NOTICE TO ALL FIRMS

Date: April 21, 2025
To: All Prospective Bidders
From: Sam Li
Director of Procurement Services
Re: Addendum Number 2
IFB # C1585 – Pomerantz New Fire Alarm System

SEAL & SIGNATURE:	DATE:	03-21-2025
	PROJECT No:	8969.74
	DRAWING BY:	DG
	CHK BY:	WM
	SCALE:	3/32" = 1'-0"
	DWG No:	
FA-100.00		
CADD FILE:	DOB page: 3 OF 23

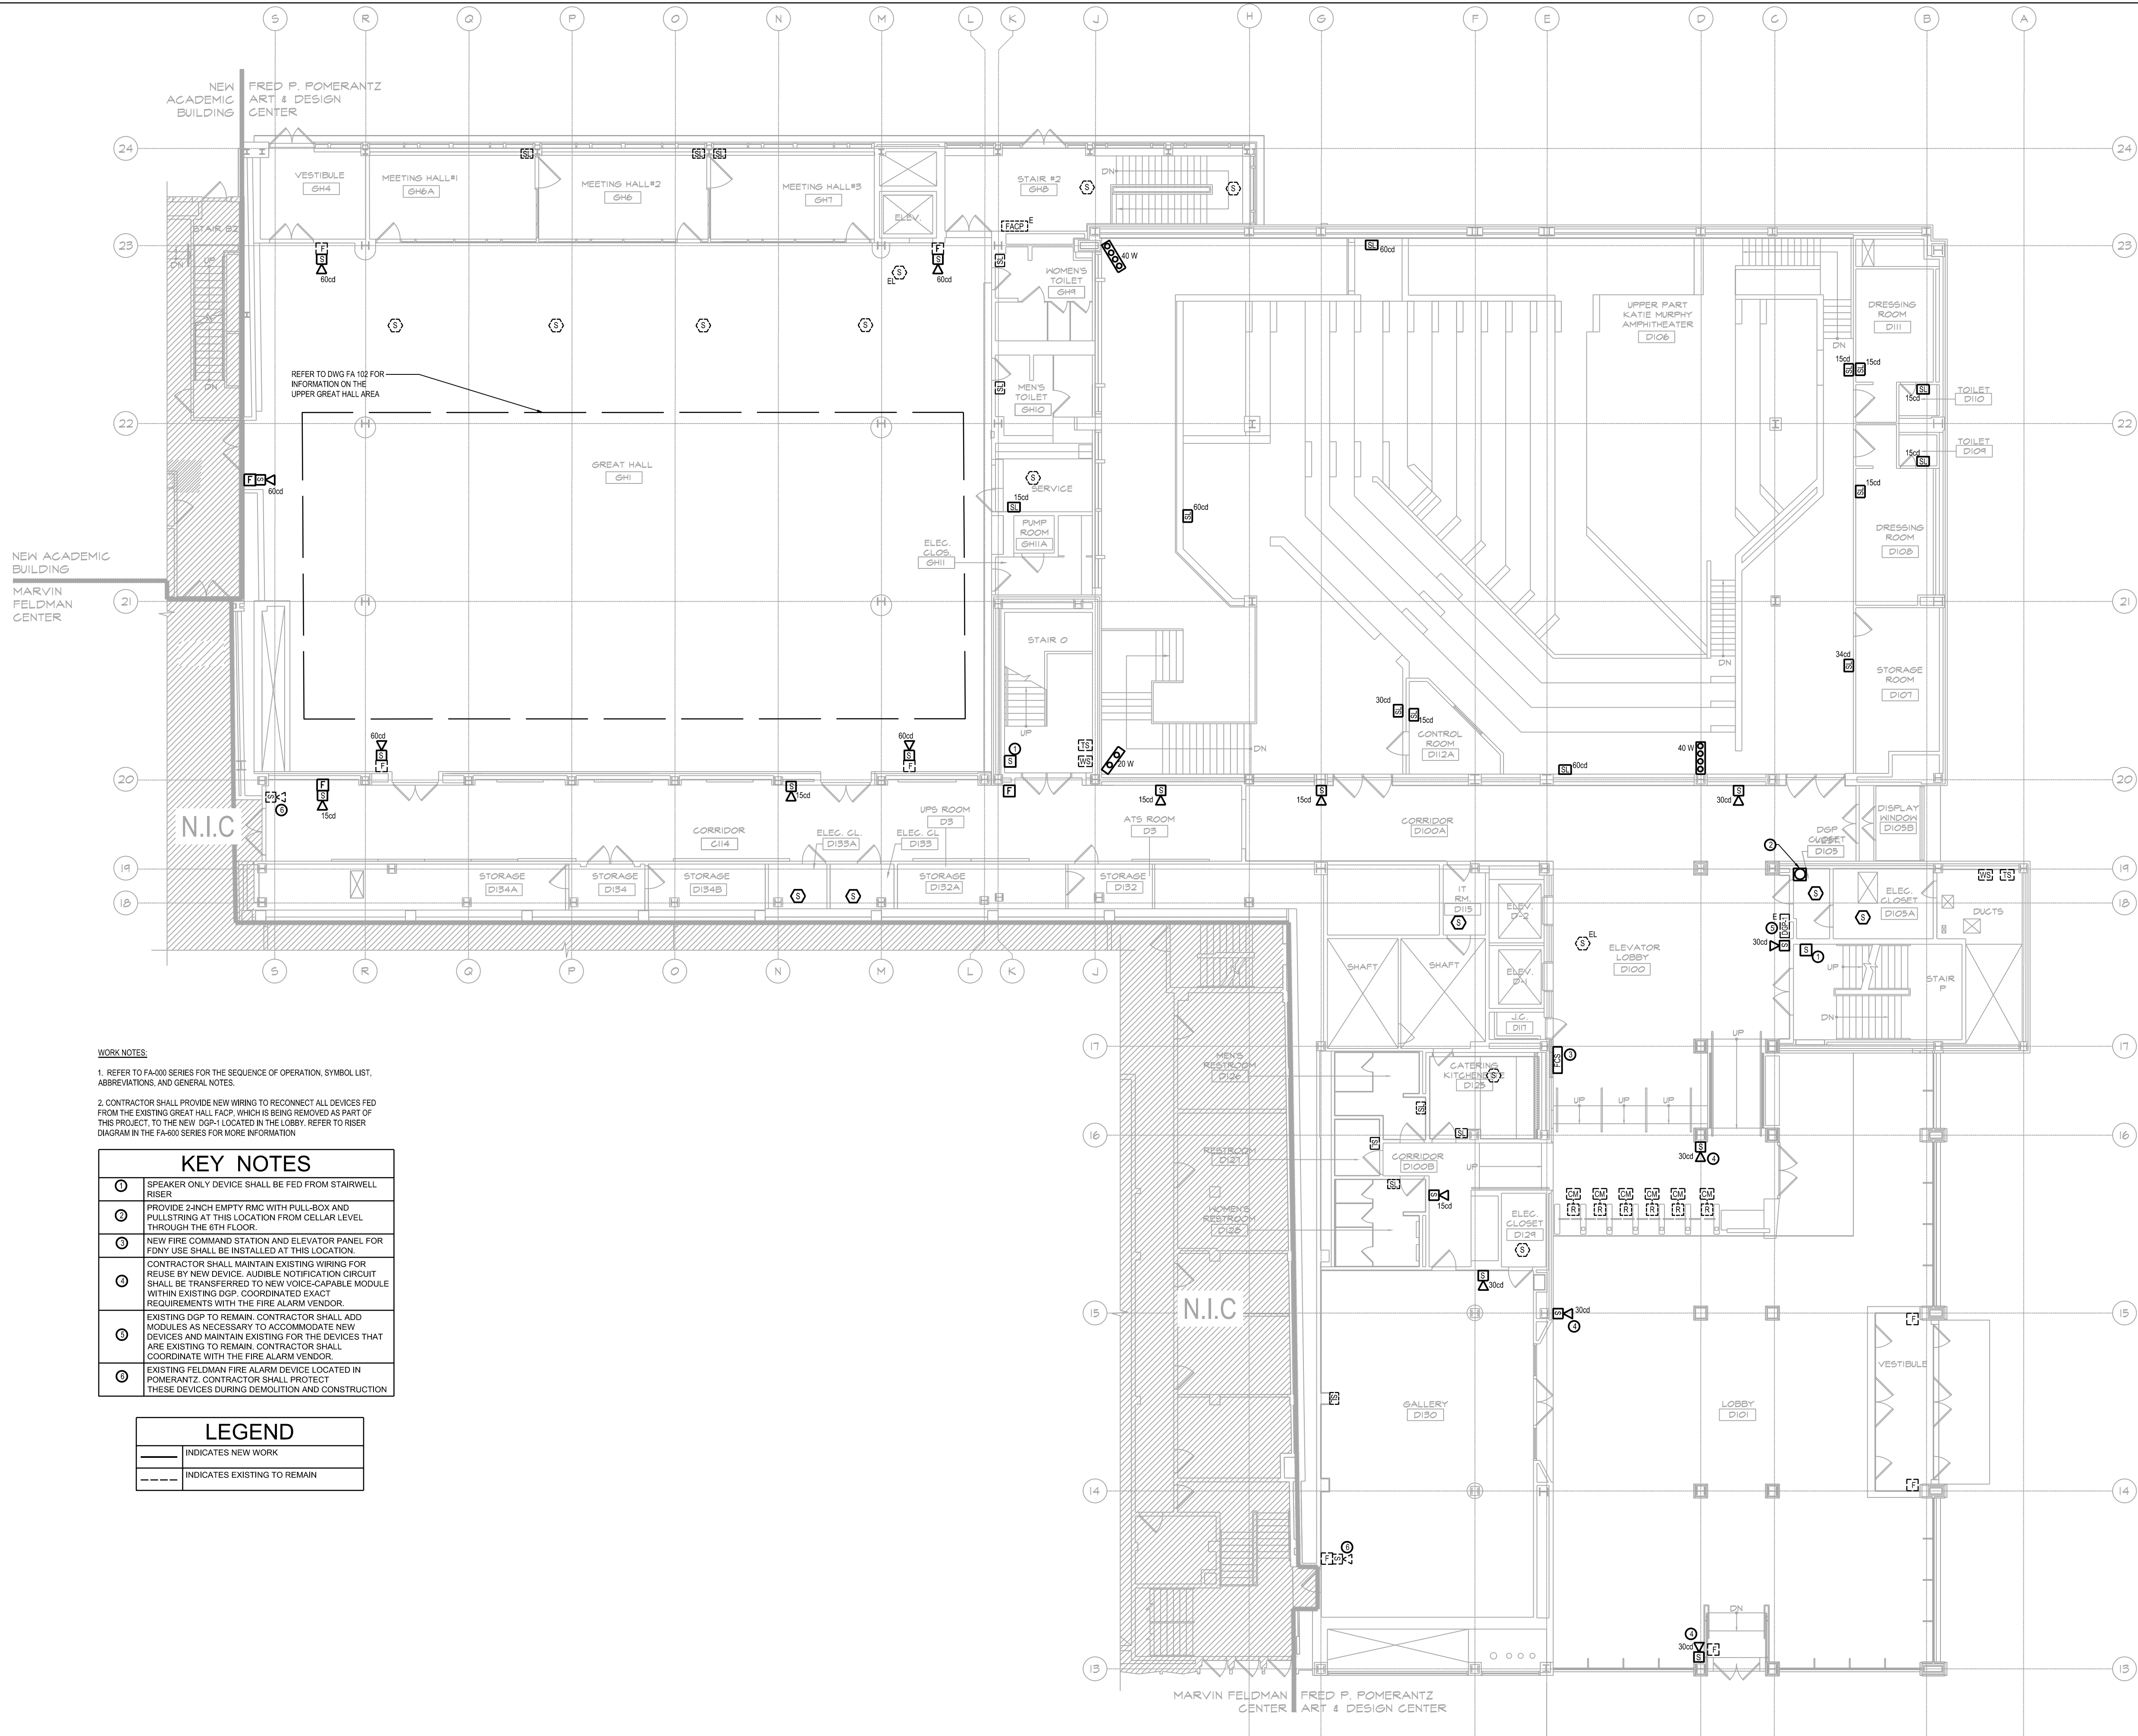
Q32. Drawing FA-601.00 calls for a Smoke Detector in Tele Closet. DC24. Drawing FA-100.00 doesn't call for a device in this room. Please advise.

Q33. The Smoke Detector located in Machine Room GHC16 on drawing FA-100.00 isn't called for on drawing FA-601.00. Please advise.

Q34. Drawing FA-100.00 is missing the numbers in the Key Notes.

A33. Drawing FA-601 has been amended to include this smoke detector.

SEAL & SIGNATURE:	DATE:	03.21.2025
	PROJECT No:	8969.74
	DRAWING BY:	DG
	CHK BY:	CTD
	SCALE:	N.T.S.
	DWG No:	
	FA-502.00	
CADD FILE:	DOB page 12 OF 23

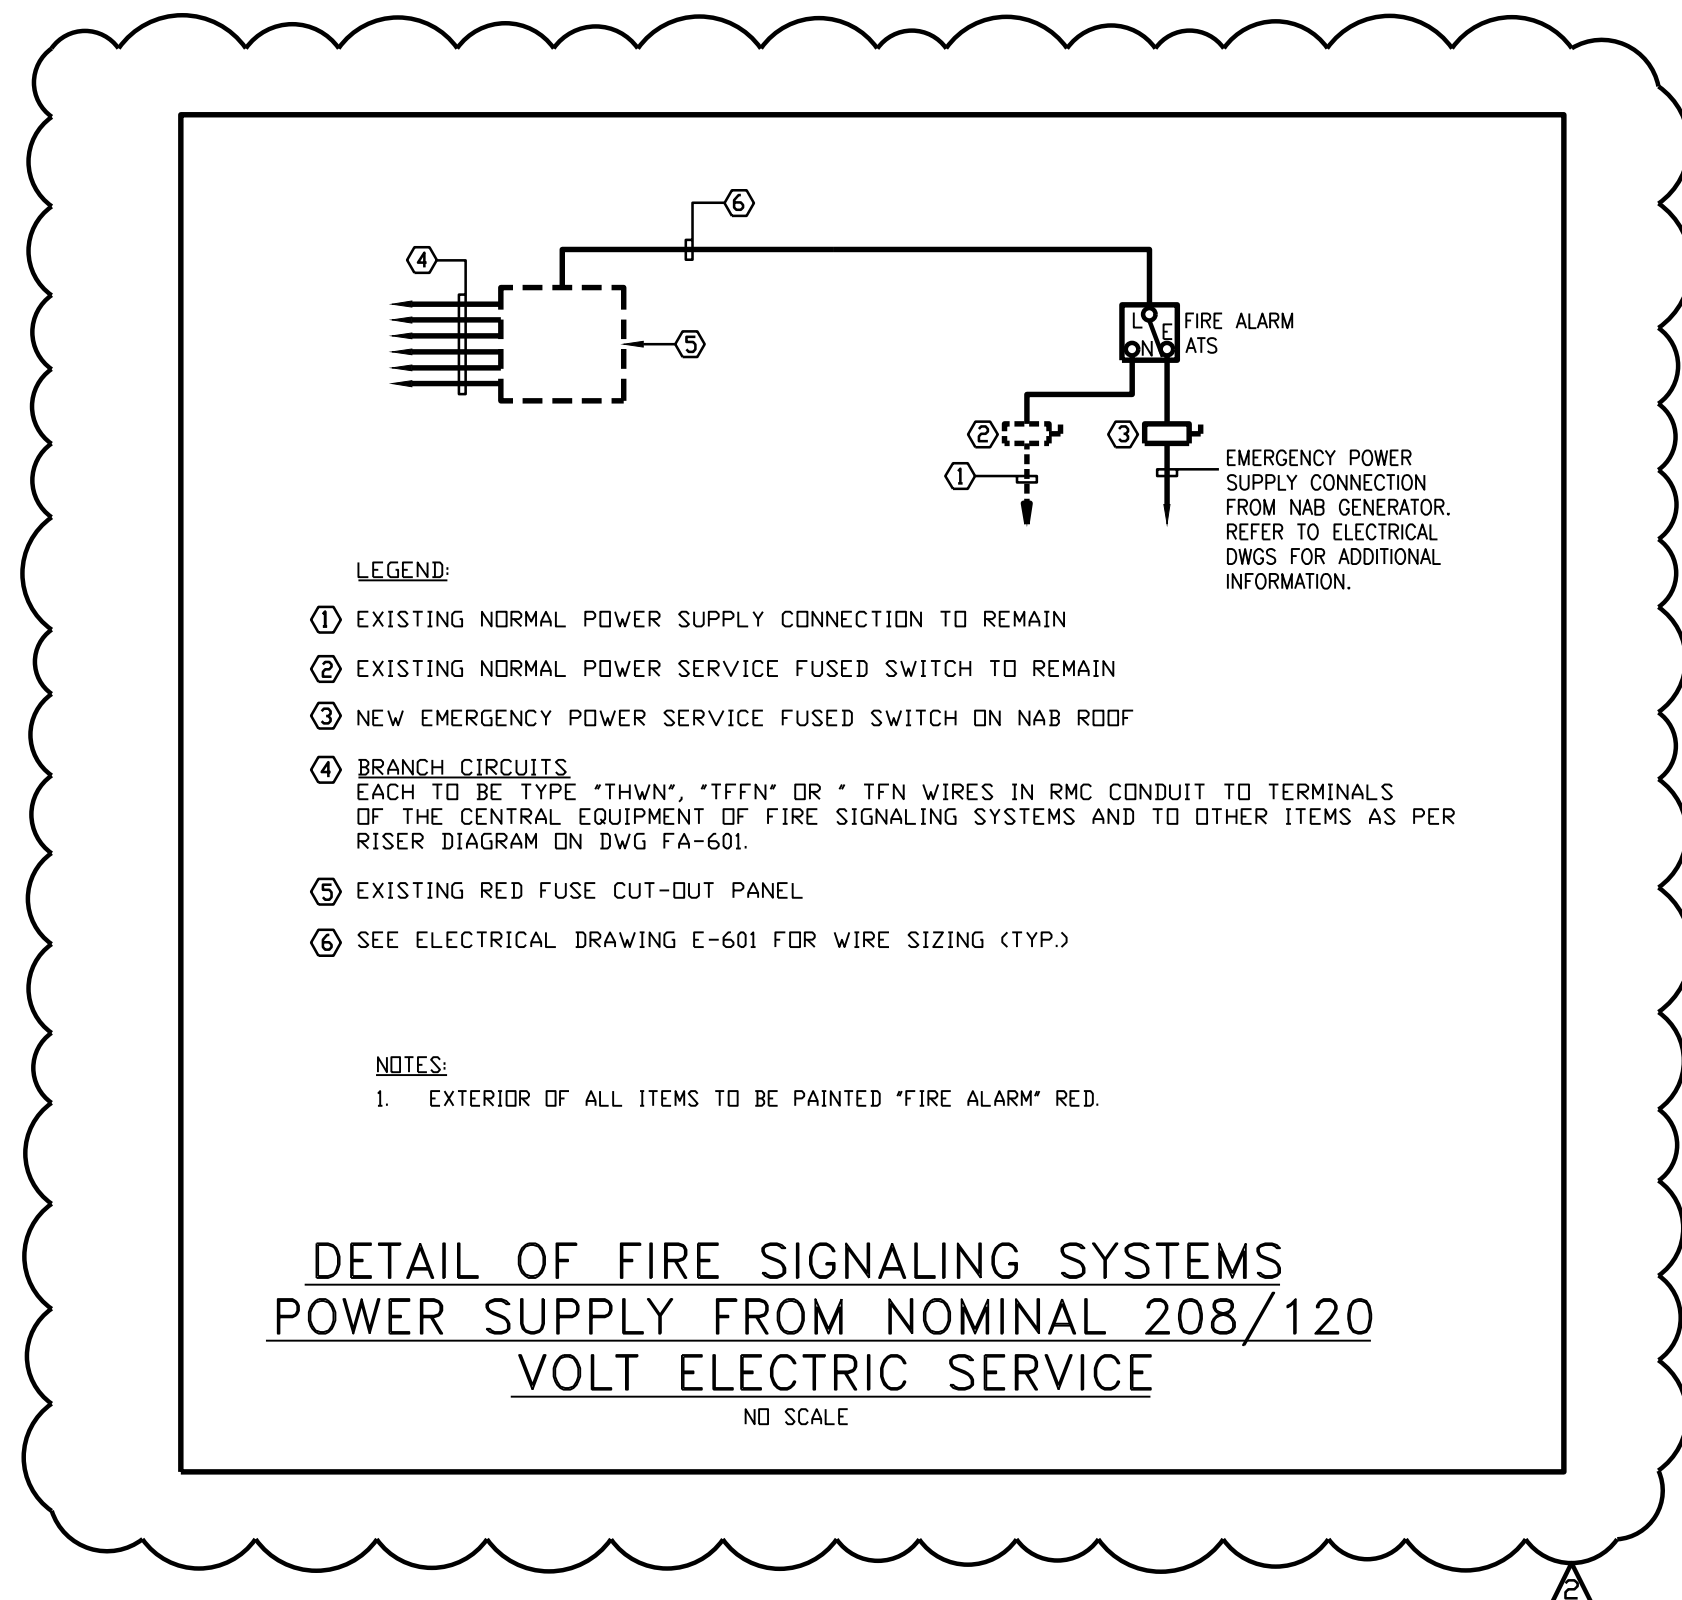
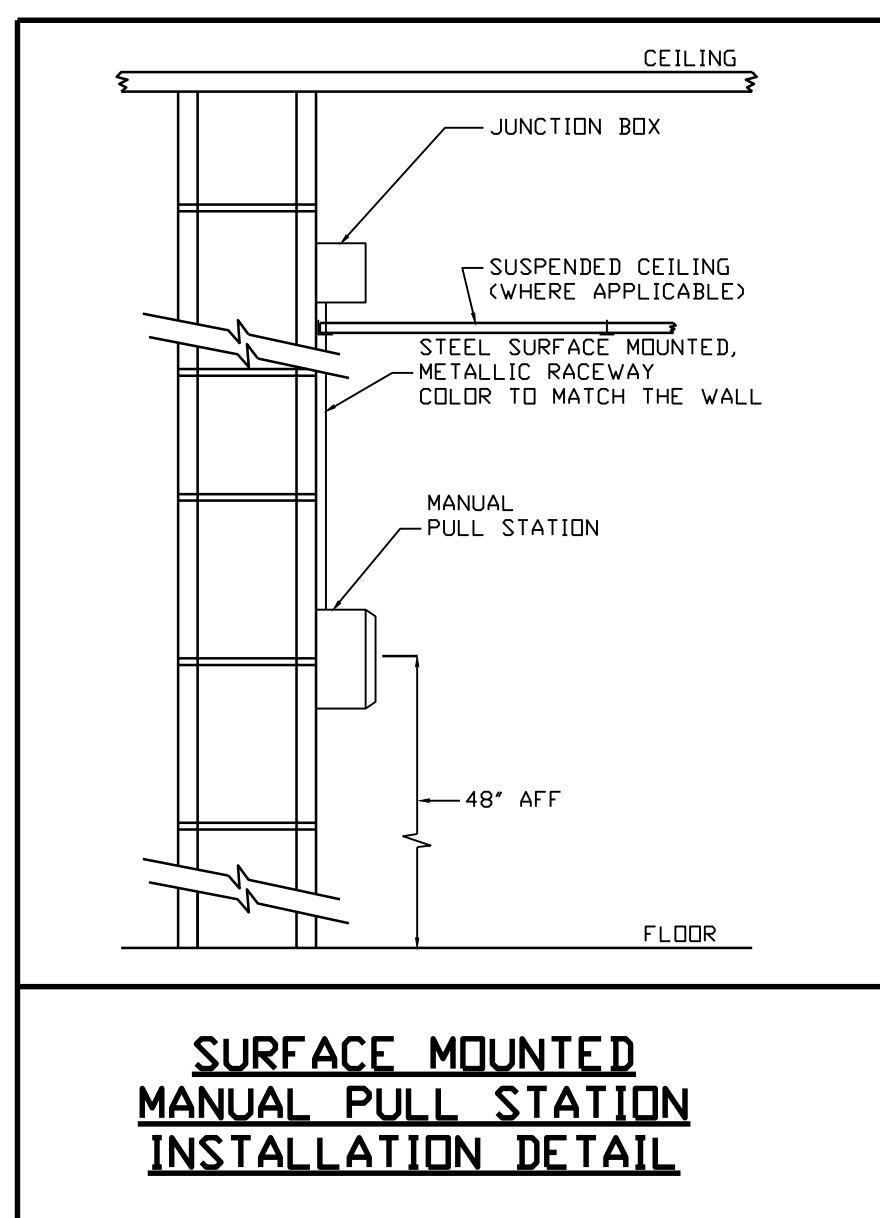
Q16. Drawing FA-502 Detail of Fire Signaling System Ledge notes is not in order and note #5 is not correct and note#6 is missing.

A16. This is a graphical issue. The notes will be moved to clear the misprint. The detail will be modified.
